FINAL PRODUCT/PROCESS CHANGE NOTIFICATION #16476

Issue Date: 19-May-2010

TITLE: Qualification of Serial I²C EEPROM devices CAT24C04, CAT24C08, CAT24C16, CAT24C32 and CAT24C64 for fabrication at ON Semiconductor's Gresham, Oregon Wafer Fab, and marking updates for product using Gresham die, to differentiate from product using the current OKI Semiconductor die.

1) PDIP 8LD (L)

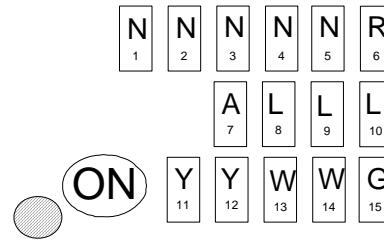
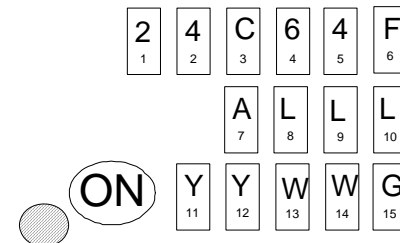
New Gresham die

Top Side Marking

- 1-5: Device name (5 char)
- 6: Production Revision
- 7: Assembly location
- 8-10: Assembly Lot Number
- 11-12: Production Year
- 13-14: Production Week
- 15: Pb-free (fixed as "G")
